State of California
The Resources Agency
DEPARTMENT OF WATER RESOURCES
DIVISION OF SAFETY OF DAMS

INSPECTION OF DAM AND RESERVOIR IN CERTIFIED STATUS

Name of dam Oroville Dam Dam No. 1-48 County Butte
Type of dam Earthfill Type of Spillway Gated Concrete Weir and Chute
Water is 12.53 feet above spillway crest and 95.67 feet below dam crest.
Weather Conditions Sunny, hot, calm
Contacts made Alex Samaan, Oroville Field Office
Reason for inspection Periodic Evaluation (2nd inspection)

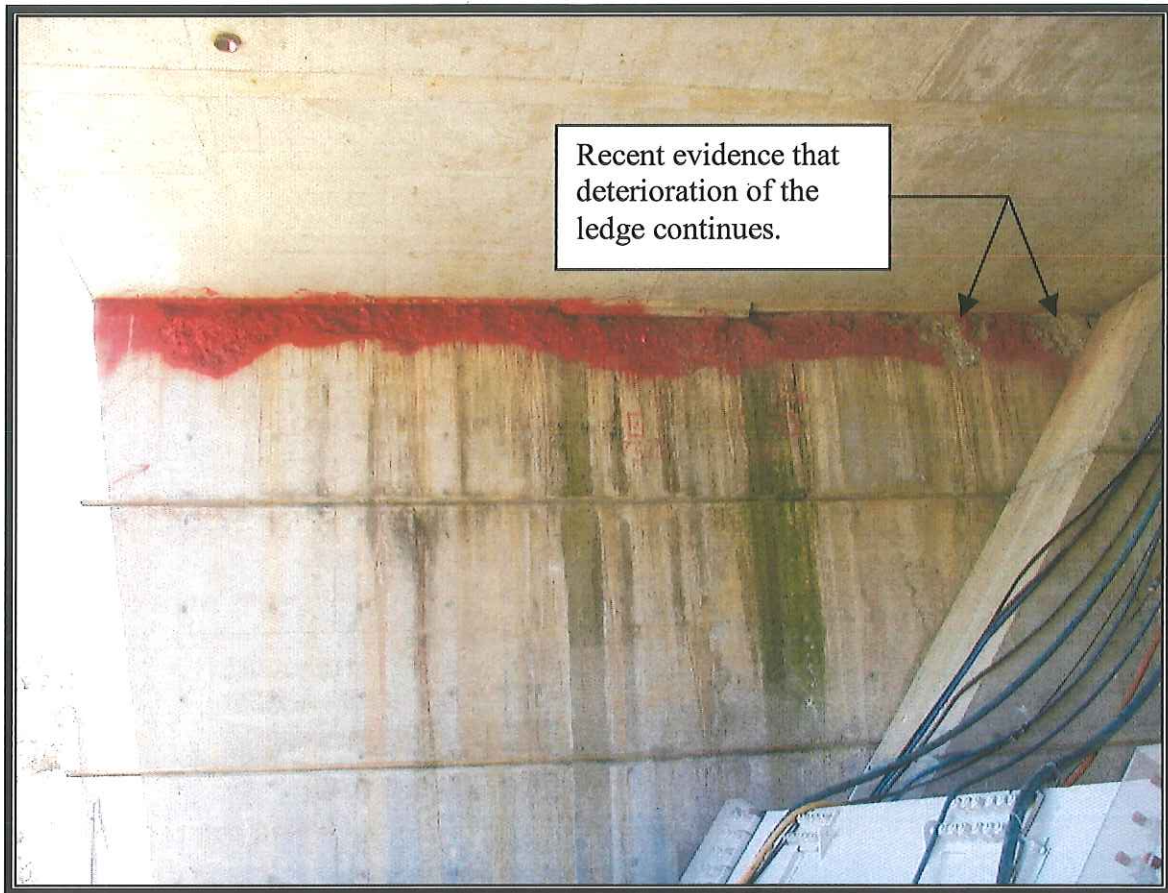
1. This view of the right bridge abutment shows recent deterioration of the bridge support. Consideration should be given to devising a repair.
